November 2020

**Reference of the PR19 final determinations:  
Costs and outcomes – response to  
provisional findings responses**

**Figure A4.1: Wholesale water power costs versus number of booster pumping stations**

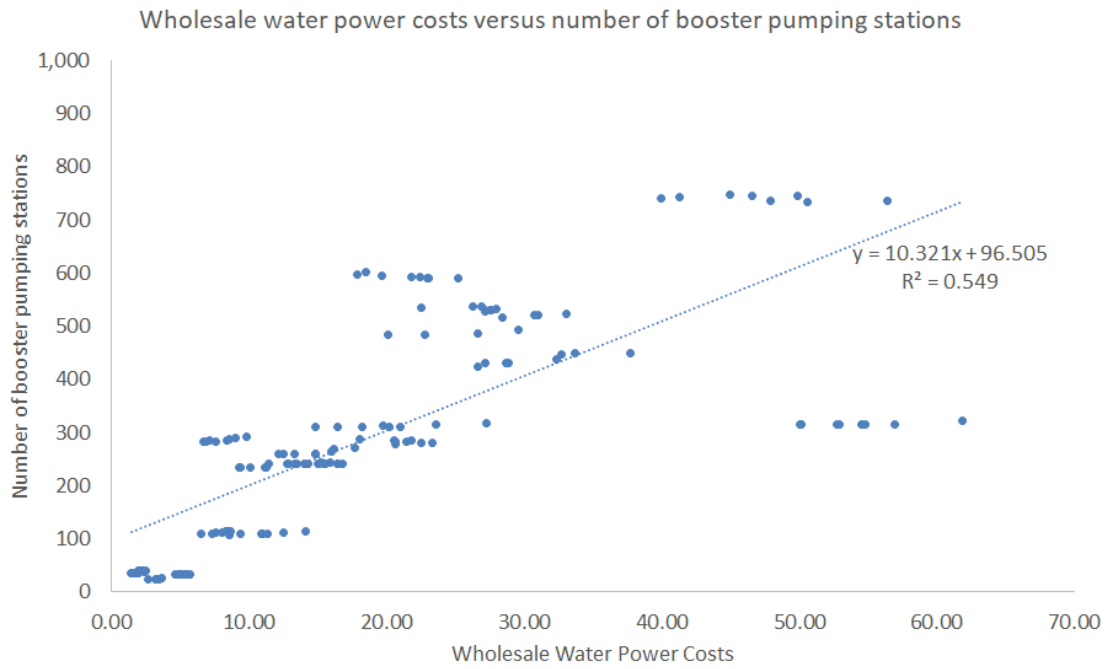
A4.9 The evidence presented by Anglian Water is very selective and does not provide a full picture. Operating in a flat region will require water to be pumped across relatively longer distances but there are many other factors that affect pumping costs that Anglian Water does not consider:

**Figure A4.2: Wholesale water power costs versus average pumping head (wholesale)**

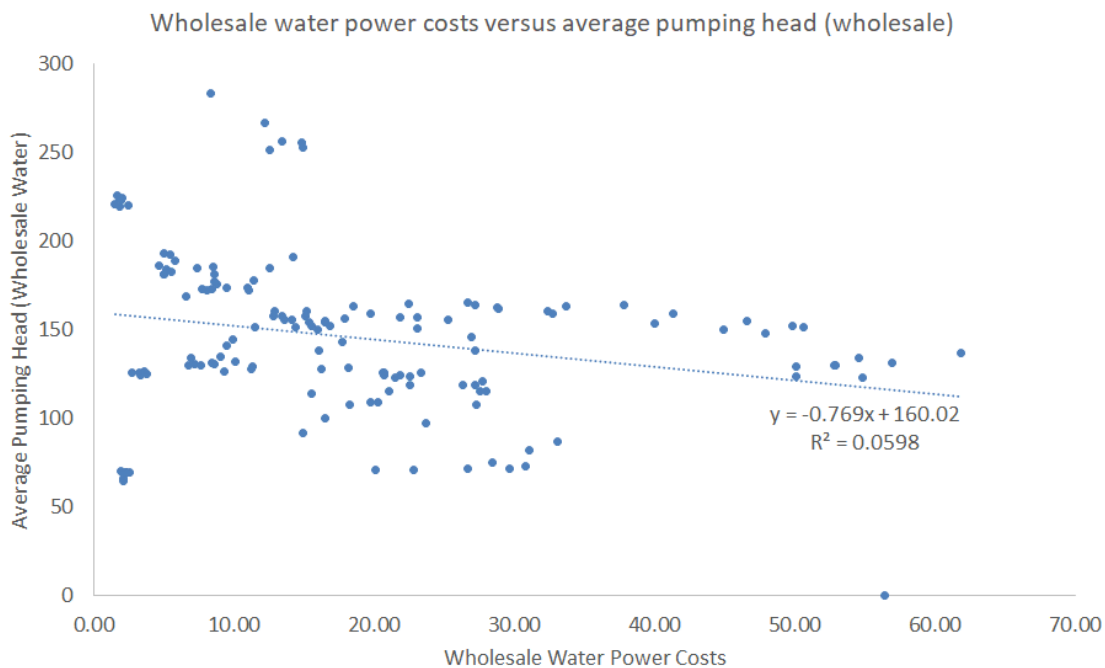
- A4.6 The inferior quality of the APH data relative to the other wholesale water explanatory variable data is demonstrated in the figure below, which presents the most common confidence grade across companies for each variable over the historical period.<sup>143</sup>

**Figure A6.1: Wholesale water modelled base costs, comparison of the last year of expenditure to the average of the AMP**

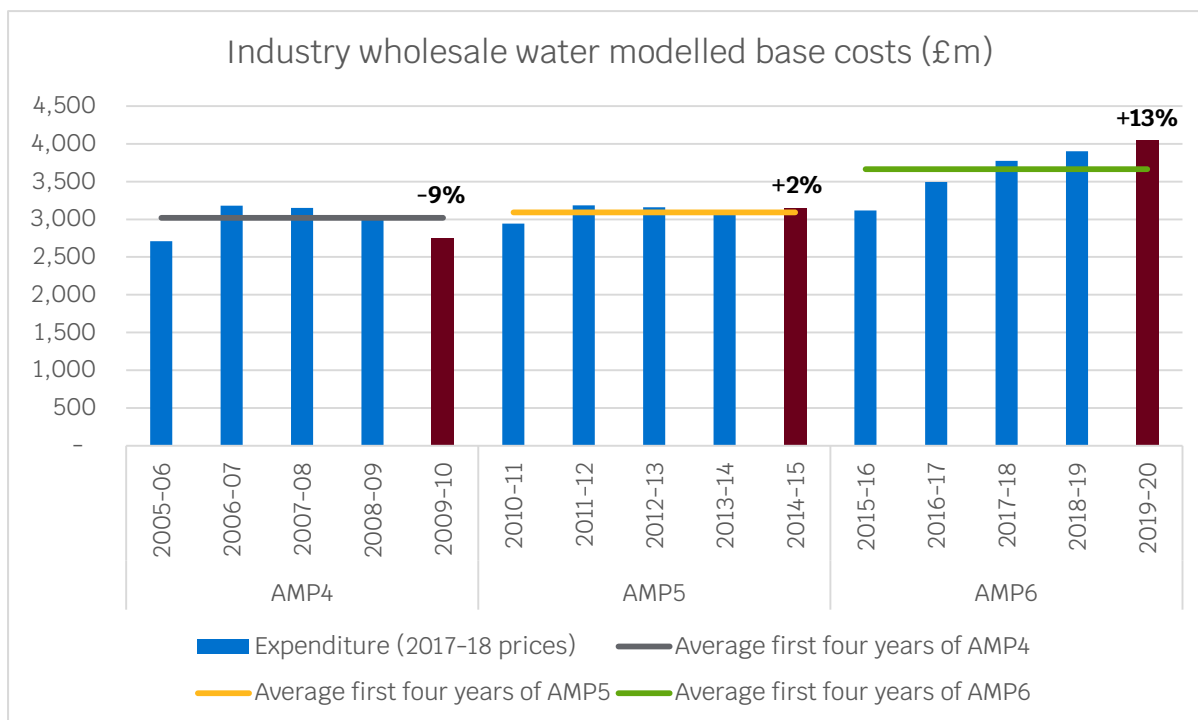
- A6.4 The cost data of 2019–20 is heavily affected by pre-spending for 2020–25. This is evident from companies’ APR commentaries and responses to queries.<sup>165</sup> In wholesale water, it is also evident when comparing the expenditure in 2019–20 to the average expenditure in the price control period. Typical cyclical nature of expenditure within price controls is such that the last year of a price control period has relatively low expenditure relative to mid-year. However, as shown in Figure A6.1, wholesale water expenditure in 2019–20 was 13% (or about £380 million) higher than the average of the other years in AMP6. For comparison, in previous AMPs the closing year was between –9% and +2% higher than other years in the same AMP.
